RESPONSE

A retrofit hurricane tie that connects the roof to the exterior walls on an existing building. Parallel webs allow attachment to opposite sides of a roof rafter, and a perpendicular base member allow attachment to the outside wall. An offset web, and unique bends between the rafter webs and base member allow the connector to clear blocking and frieze boards beneath the roof.

FIG. 1

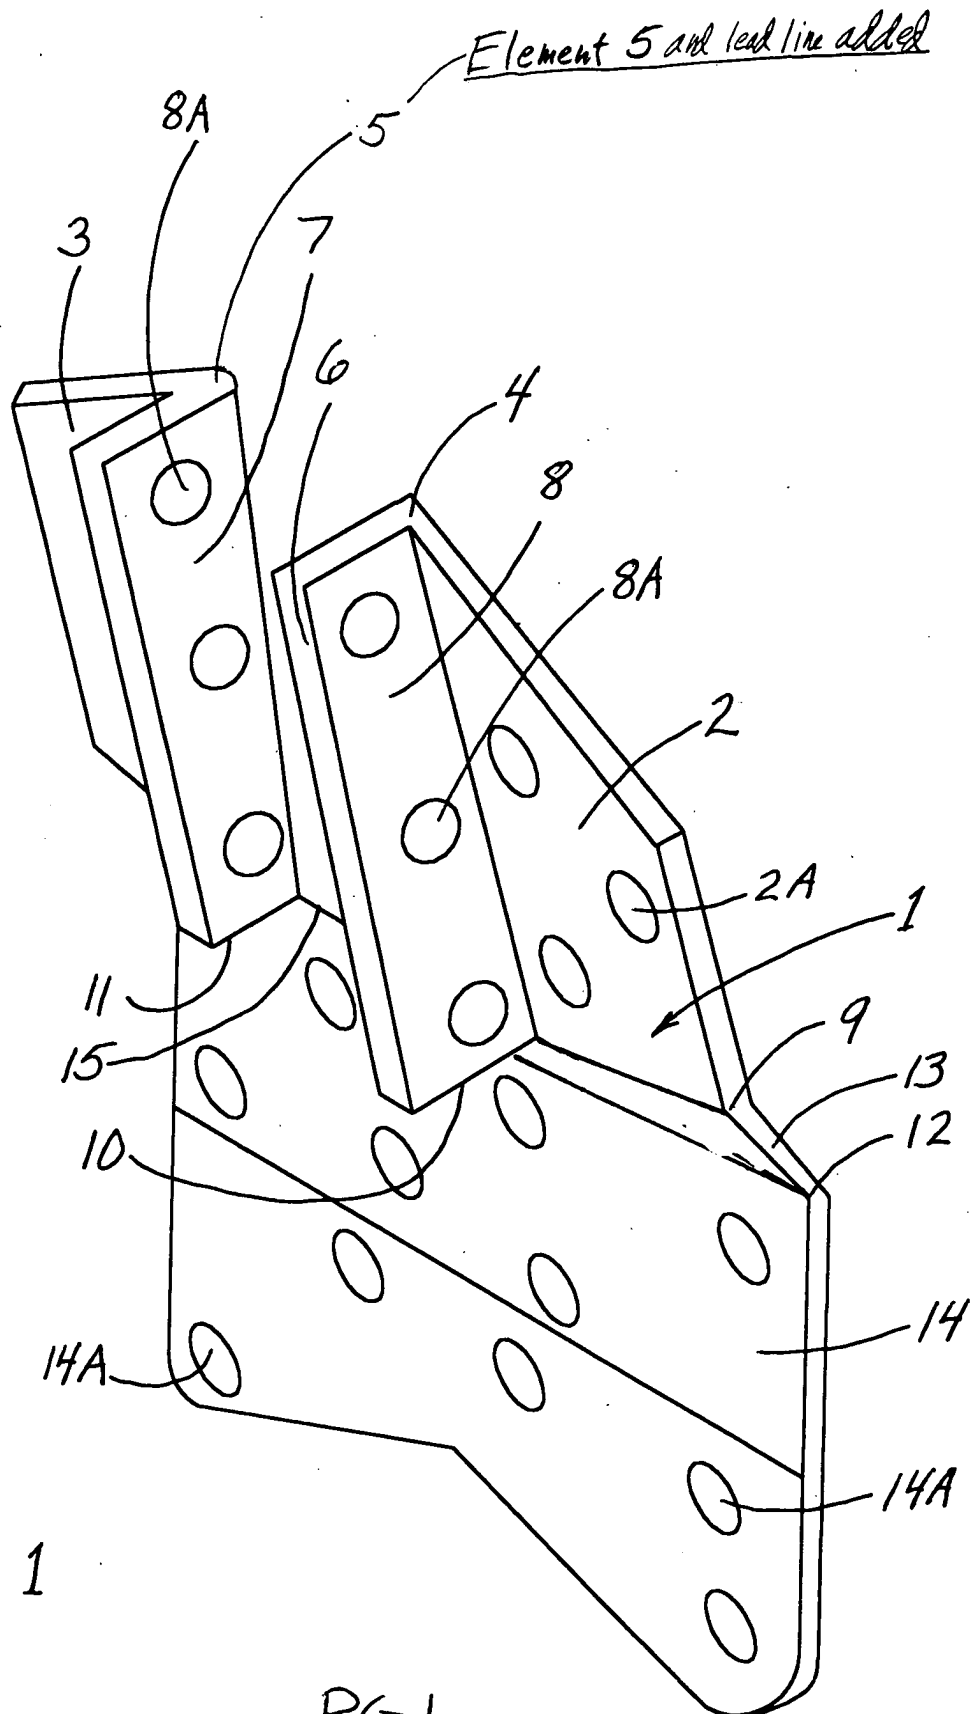
1. Add "Fig. 5A" to roof plate 39, shown on Fig. 5.
2. On Figs. 2, 3, and 6, change the bracket referring to the top plate to a lead line.
3. On Figs. 3, 4, and 5, change the bracket referring to the seat 15.
4. On Fig. 6, delete reference numerals 44 and 45, and their lead lines.
5. On Fig. 1, add reference numeral 5 and lead line.

FIG. 3

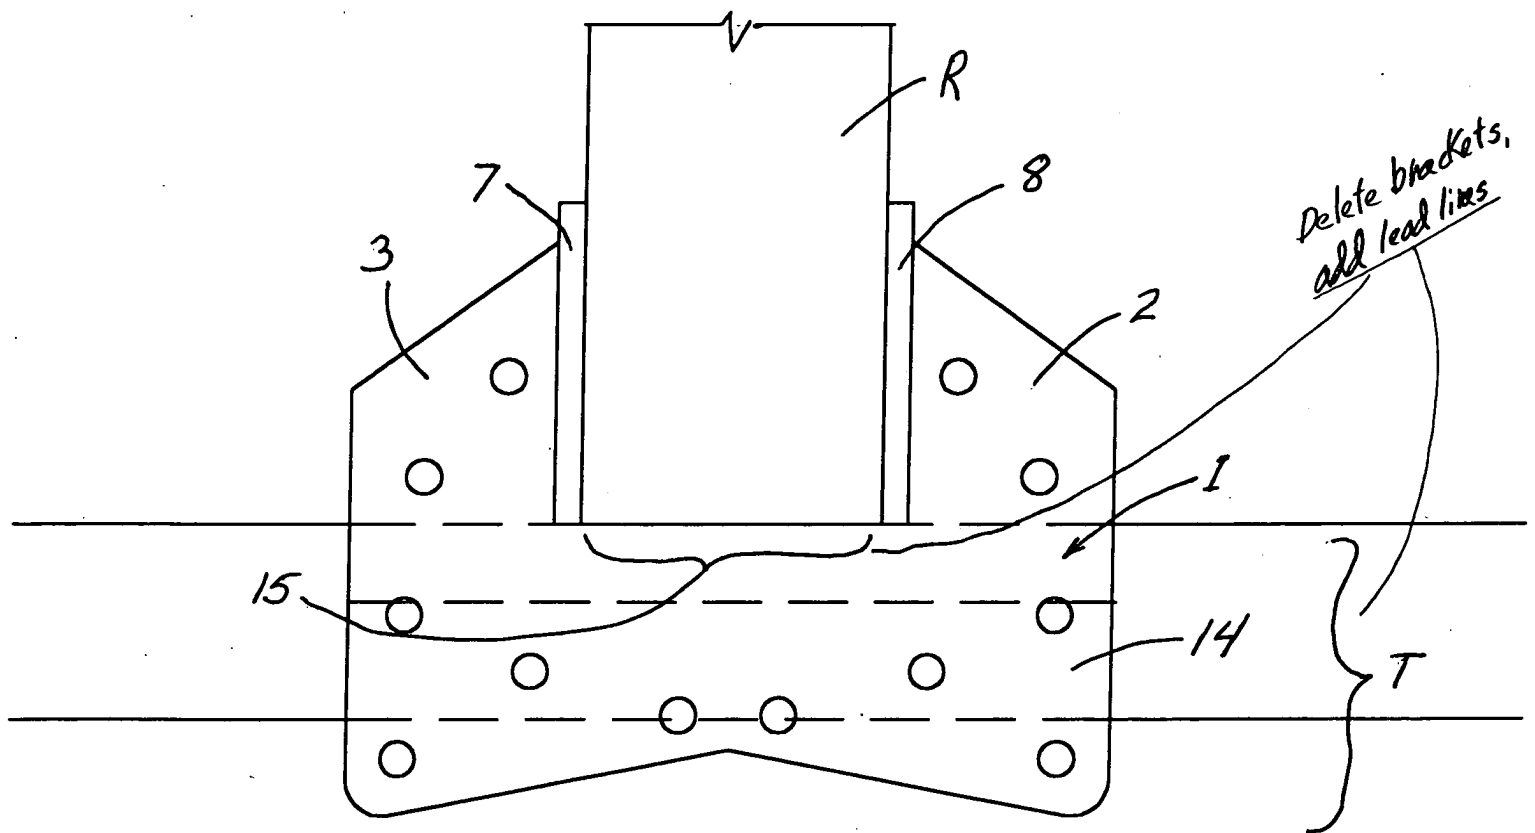
4. **The bracket shown adjacent to reference character “T” in Figures 2 and 6 is misleading. Is “T” depicting top plates or a top plate? Applicant should consider using lead lines as brackets are only used to show the components that belong to an exploded figure.** Standard practice for exterior wall framing is to use a double top plate. The applicant patterned the invention for his post-and-beam home, which uses a singular thick beam for the top plate. The invention can be used on a single beam, or a double top plate. The important function is that the retrofit invention can attach to the underlying structural top plate, from the outside of the house, by nails going through the outside sheathing. With the brackets on the drawings, the applicant intended the double members to be considered the “top plate”. The applicant will delete the top plate brackets and add lead lines on Figs. 2, 3, and 6, and delete cut line brackets on Figs. 3, 4, and 5..

FIG. 4

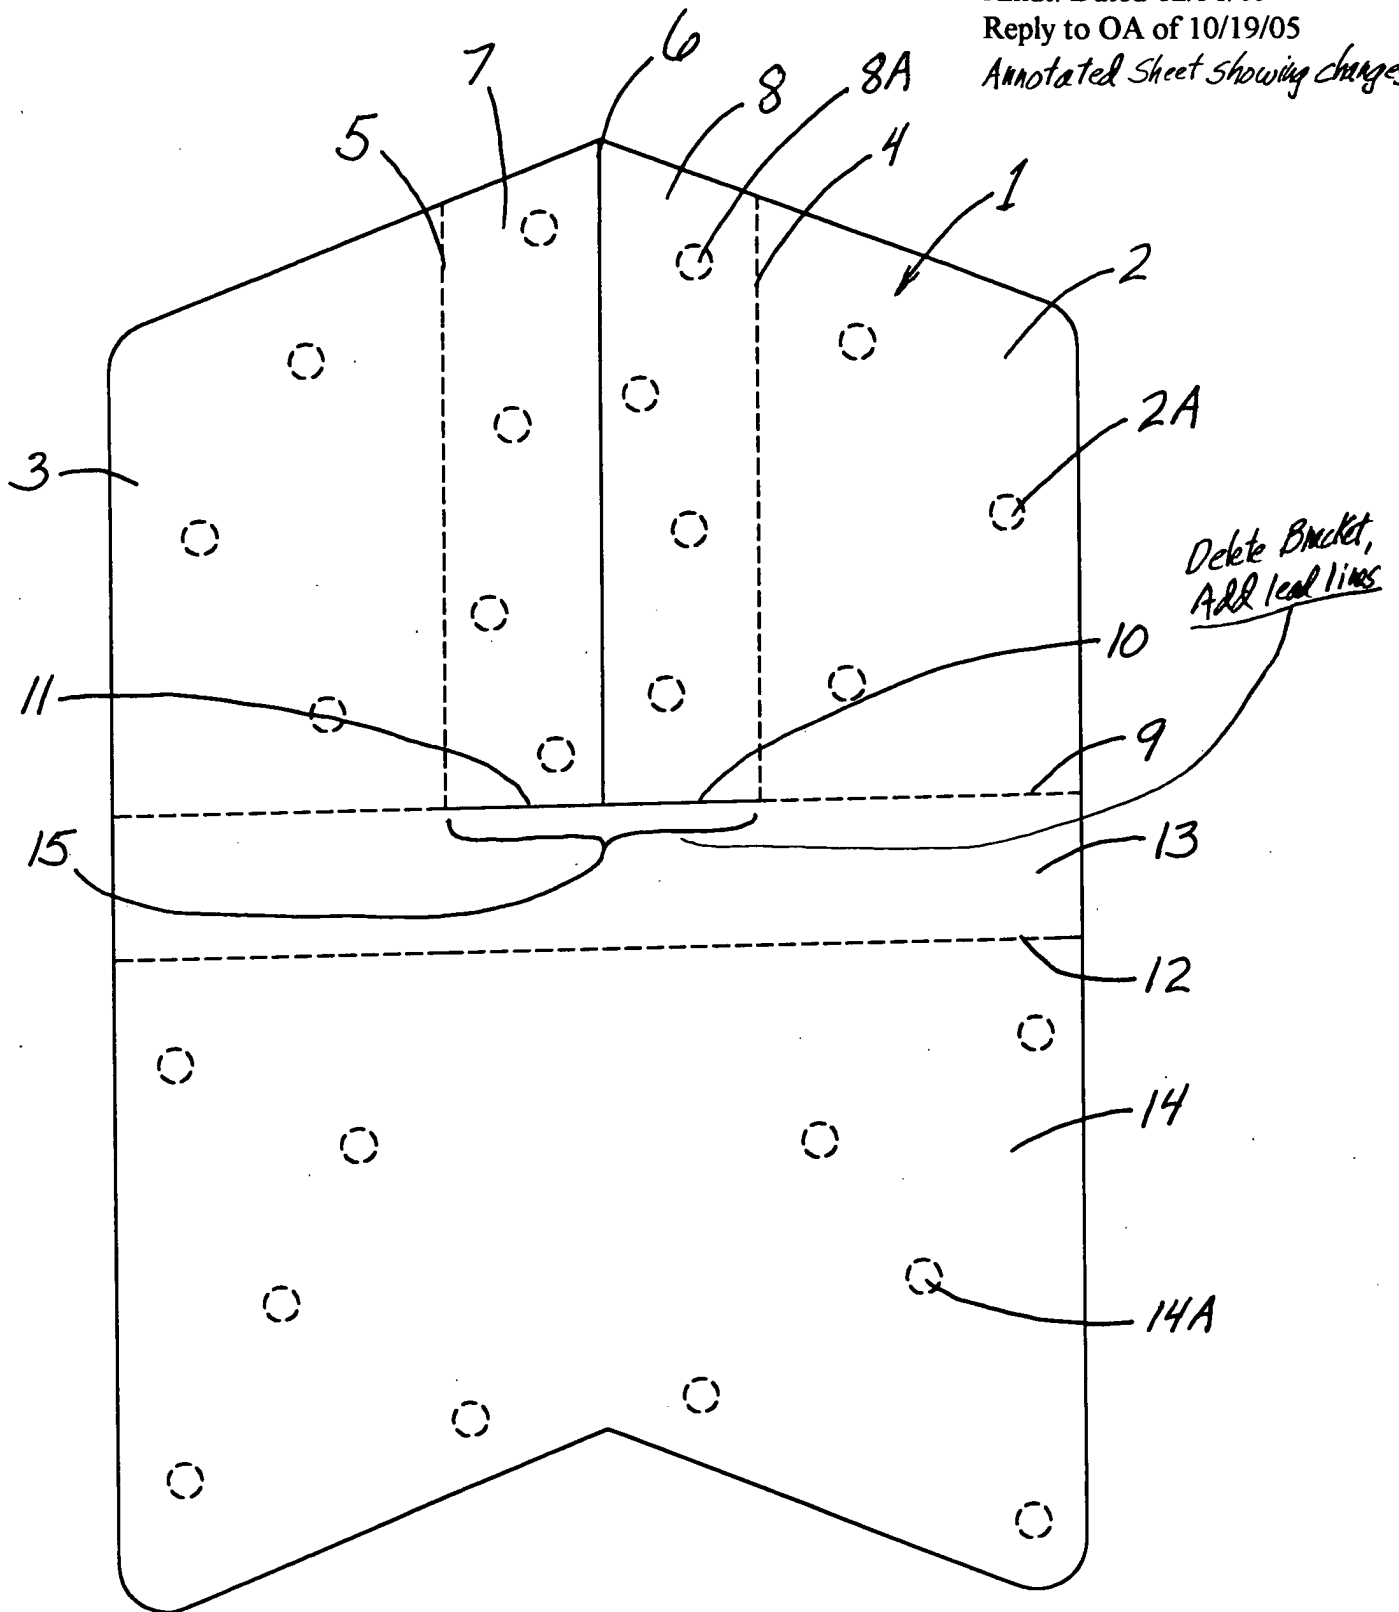
Delete bracket,
Add lead lines
